# Planning & Zoning Commission Meeting Agenda

**April 29, 2021 at 6:00 P.M.**

Consider action on the appeal of an administrative denial a Site Development Plan for First National Bank on Lot 2 of the Main & Spring Subdivision, located at 714 Spring Street, that was previously denied by the Director of Planning & Development due to non-compliance with the Bastrop Building Block (B<sup>3</sup>) Code Section 6.3.005 Alleys & Driveway Locations.

## Appeal of Site Development Plan Denial 714 Spring Street

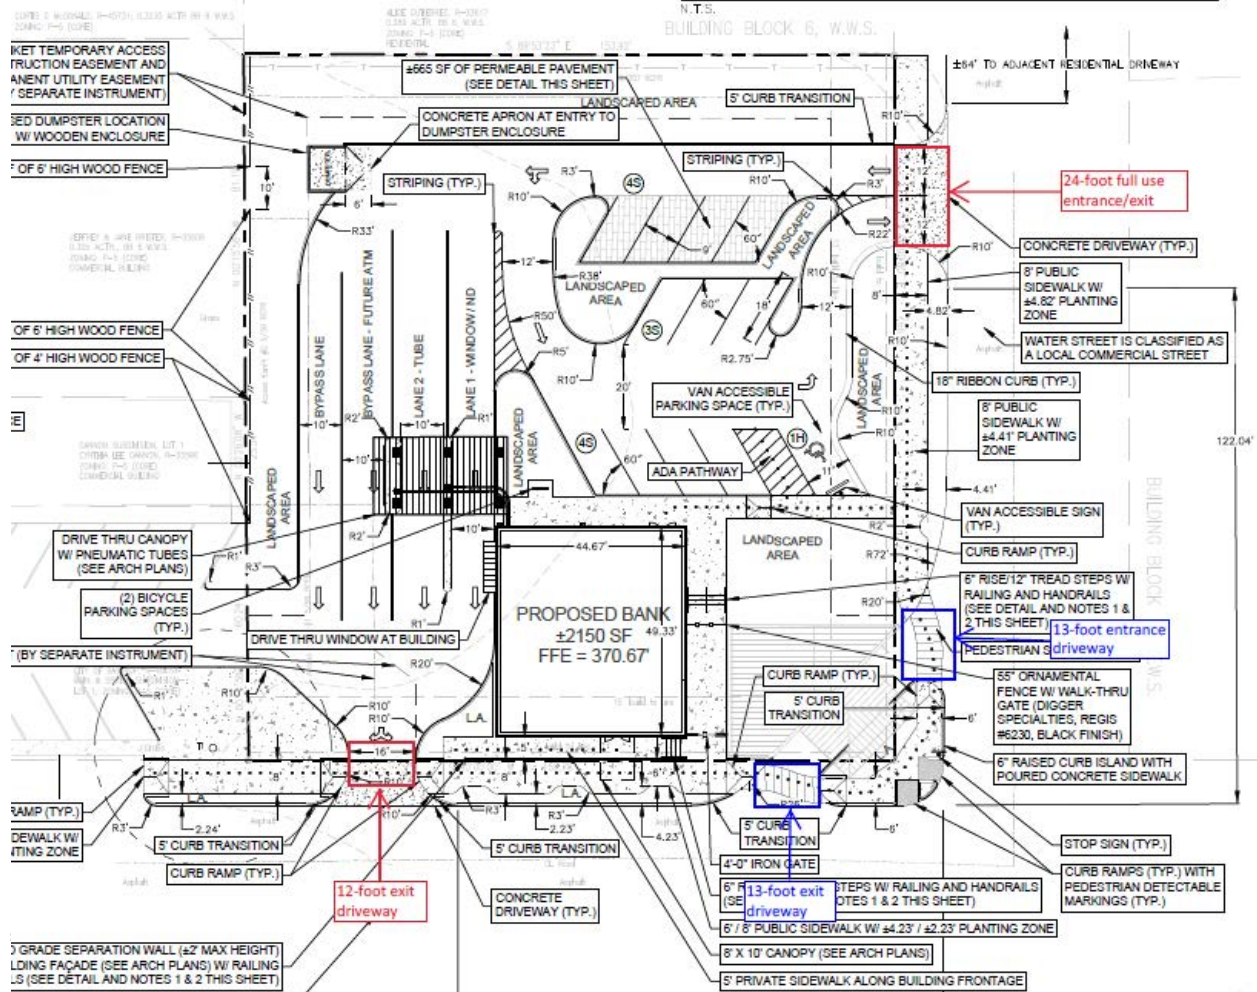
The applicant has revised the previous plan from five driveways to four and revised the widths.

Driveway Location	March 25, 2021 Draft	April 29, 2021 Draft
New Spring Street	12'	16'
Existing Spring Street	Approx. 20' crossing	Approx. 13' crossing
Existing Water Street	Approx. 20' crossing	Approx. 13' crossing
New Water Street Exit	12'	Combined into one 24' entrance/exit
New Water Street Entrance	12'

The revised Site Development Plan with the changes in driveways was submitted for P&Z consideration (Attachment 3). For the Cash Station ATM, the applicant is unwilling to close the drive thru, but is willing to narrow down the lanes from approximately 20 feet to 13 feet. On Water Street, the same driveway width cut to the sidewalk is proposed but is consolidated into one spot (24 feet).

SITE & DIMENSION CONTROL PLAN

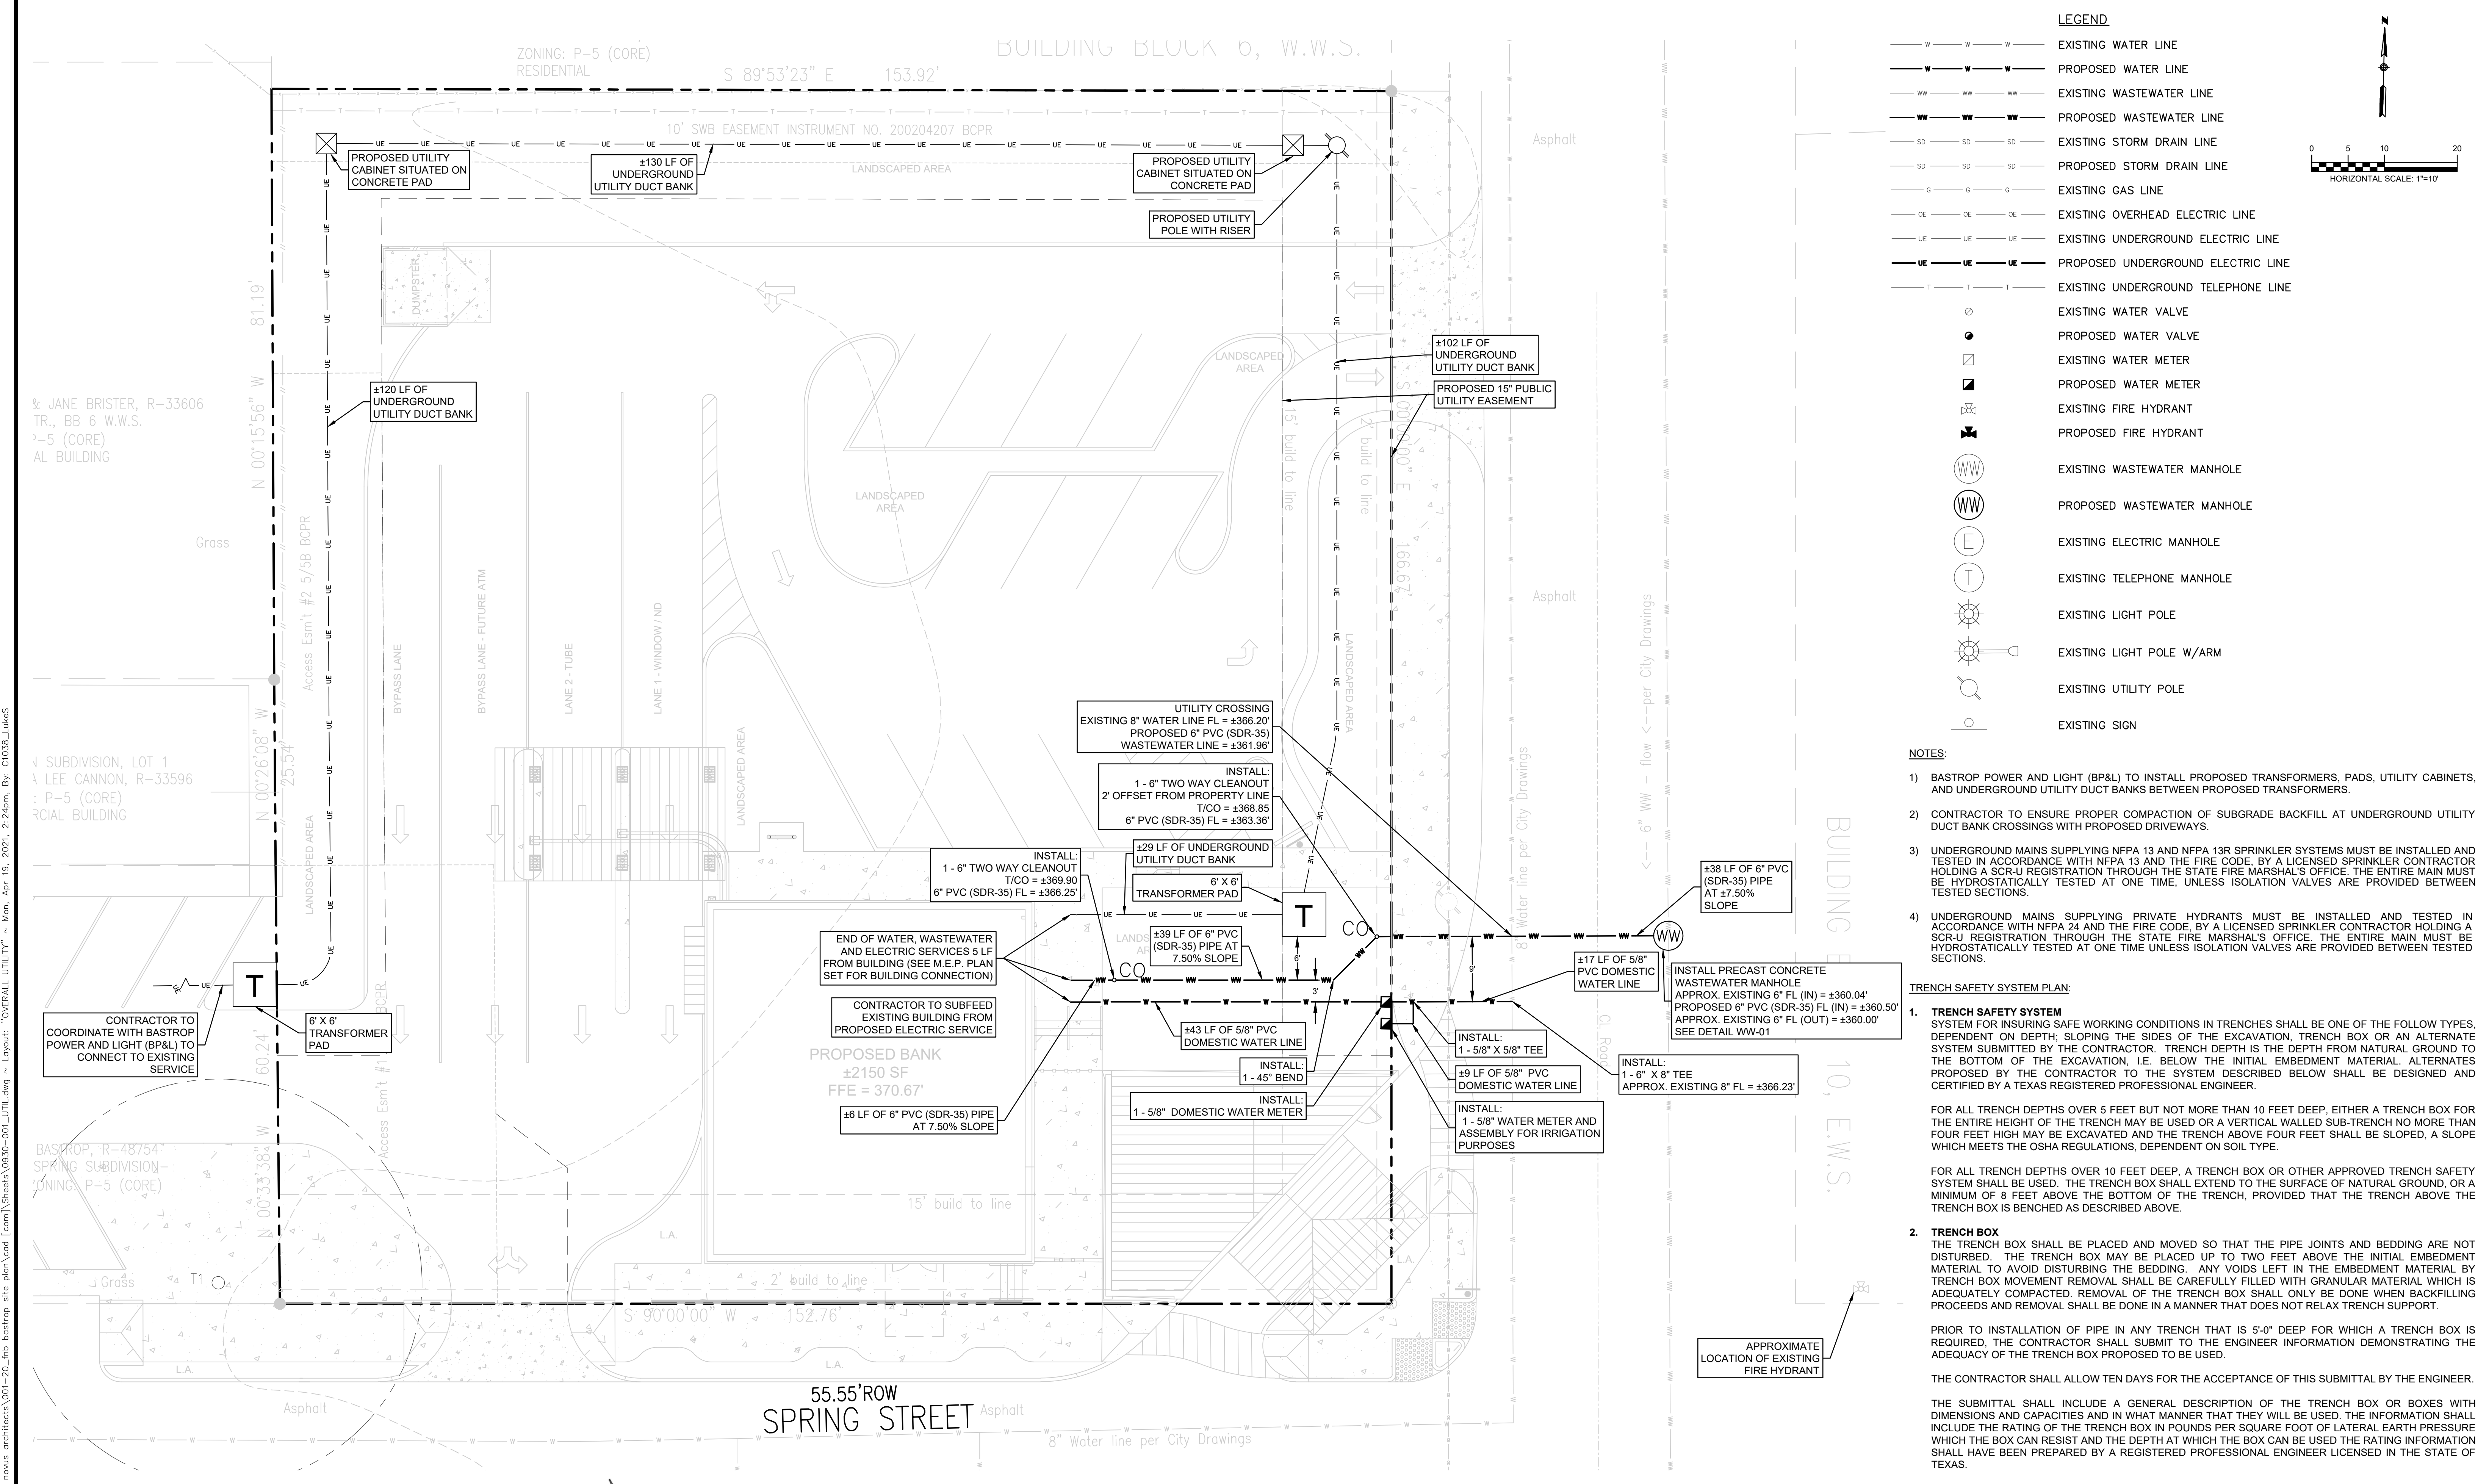
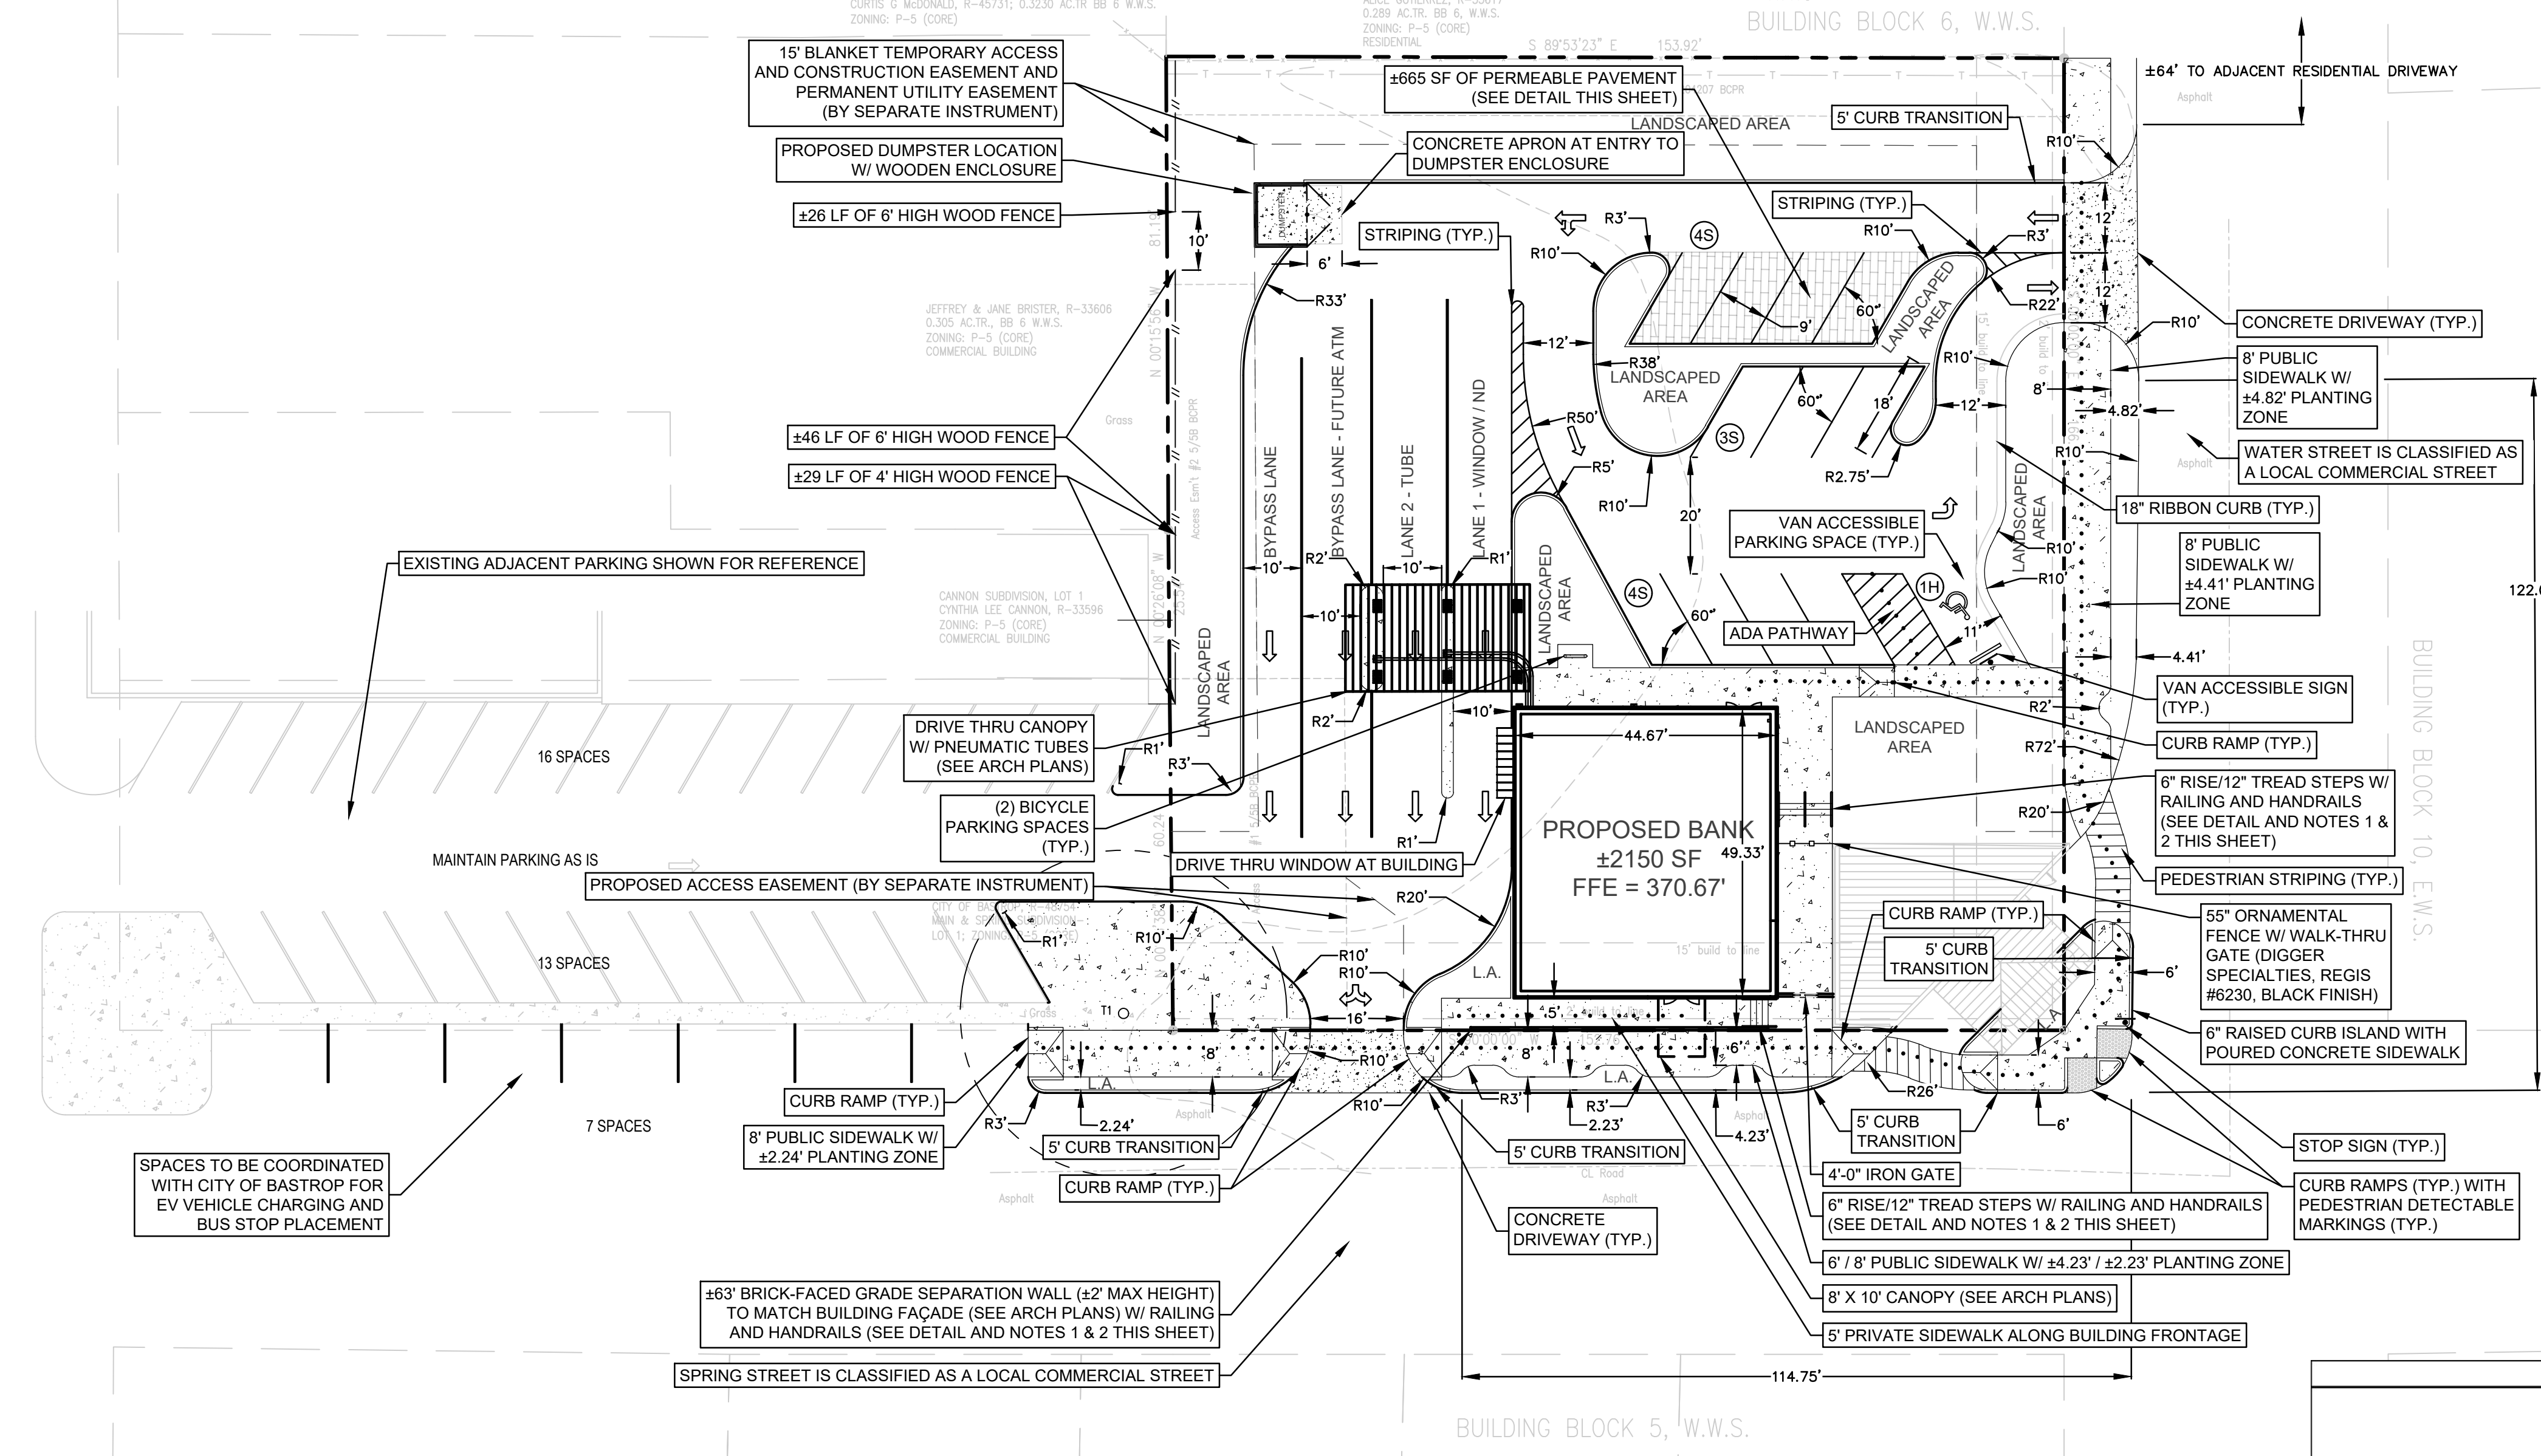
The Assistant City Manager (Acting Director of Planning & Development) has denied approval of the plan for non-compliance with the driveway requirements. Per the Code, on a corner must take access off the Secondary Frontage and sites zoned P-4 or P-5 must have the driveway set a minimum of 40 feet from the street intersection. The B<sup>3</sup> Code is designed to create pedestrian focused multi-modal streets. Allowing of multiple auto centric driveways creates multiple breaks in the sidewalk and intersections with the street driving lanes, generating conflicts for pedestrians and other auto traffic.

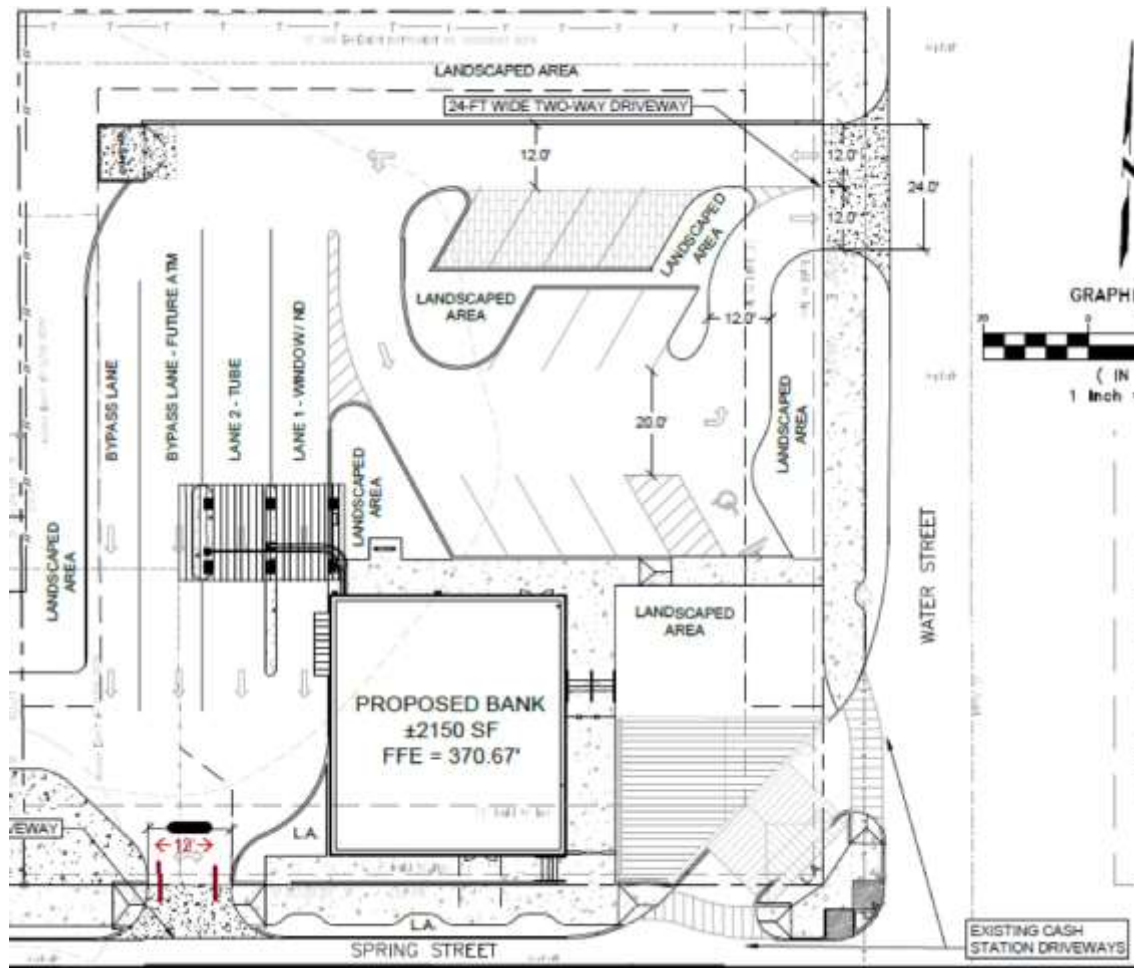
Code and Planning Issue: We had designed a 24' driveway exit to Spring Street to help relieve congestion at the exit from the Bank and City owned parking lot traffic.

Proposed Compromise: While there is support for a 24' exit driveway from adjacent business owners, we will agree to a 12' driveway per the code as a means to minimize pedestrian and vehicle conflicts.

Bastrop Building Block Code Section 6.5.003 Building Standards Per Place Type

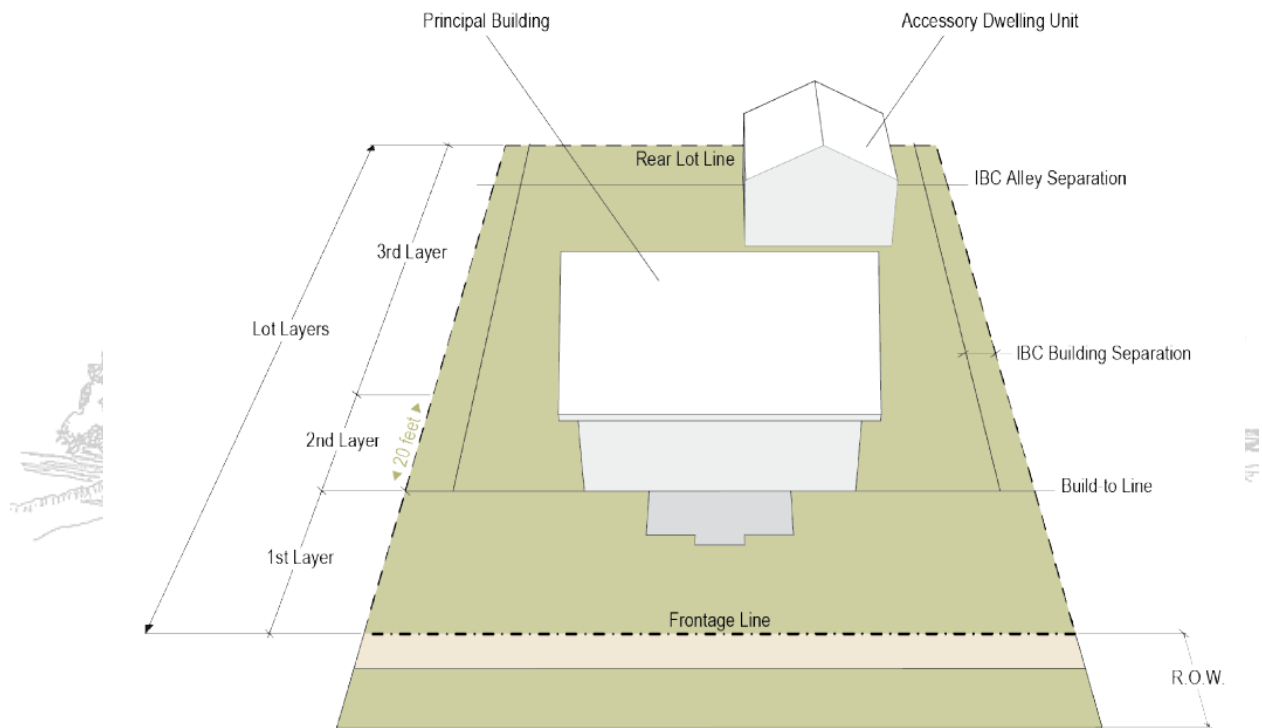
Build-to Line in P5 is 2 feet to 15 feet.
